#### REMARKS/ARGUMENTS

This Amendment is in response to the Office Action mailed September 9, 2004. In the Office Action, the Examiner objected to specification and the drawings, rejected claims 10, 14, 15-24, 22 under 35 U.S.C. §112 and claims 1-39 under 35 U.S.C. §102(b). Applicants have amended claims 10, 13, 22, 26, 28, 31, 33-37. Applicants submit that the newly-added claims introduce no new matter. Reconsideration in light of the amendments and remarks made herein is respectfully requested.

Appl. No. 09/770,995 Amdt. Dated 01/10/2005 Reply to Office Action of 09/09/2004

Sheets showing changes for Figures 1A and 2

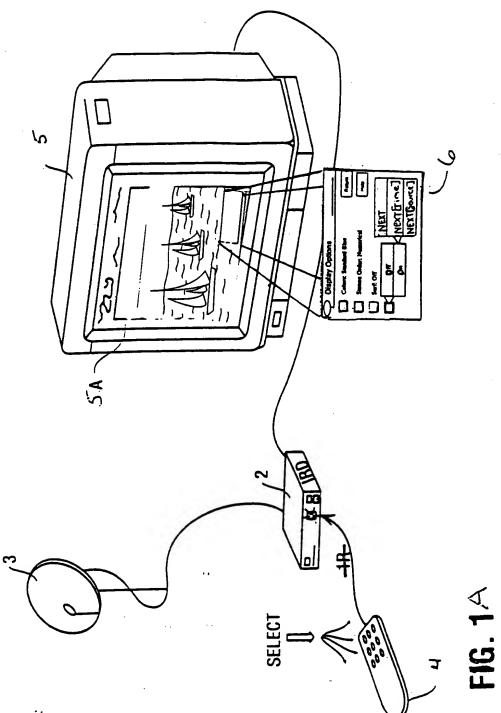
- 1. The drawings are objected to as failing to comply with 37 C.F.R. 1.84(p)(5) because they include the following reference characters not mentioned in the description: 1R and 34. In response, Applicants has amended: (1) Figure 1A to remove the reference character 1R, and (2) page 6 of the specification to include the reference character 34.
- 2. The drawings are objected to under 37 C.F.R.1.84 for unacceptable margin sizes, lines, numbers and letters, reference characters. However, the Examiner did not specifically point out the Figure number(s) to which the objections are directed. Applicants have amended Figures 8 and 10.

FIG. 2

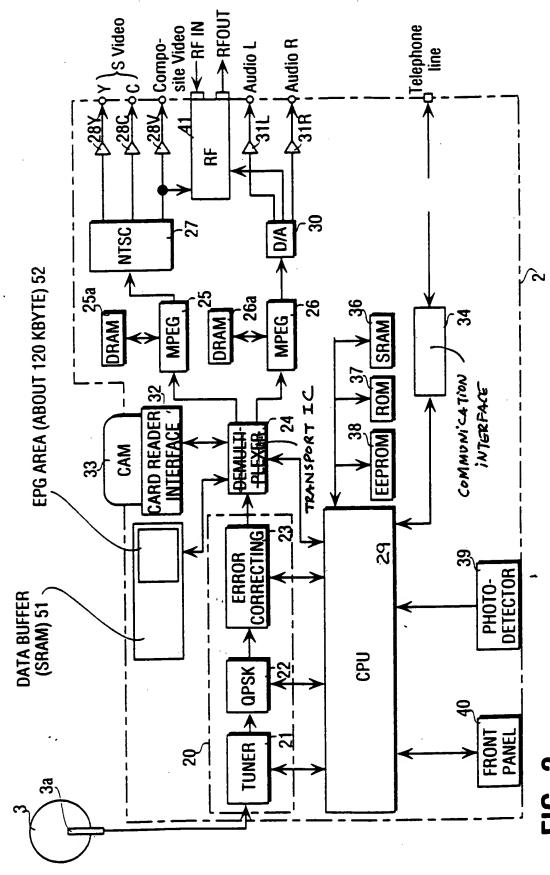
1. The Examiner objected to the specification due to minor informalities. Specifically, item 24 in Figure 2 is referred to as "demultiplexer" in the figure and "transport IC" in the specification. Applicants have amended Figure 2 to change the label "demultiplexer" to "transport IC" to properly describe the device.
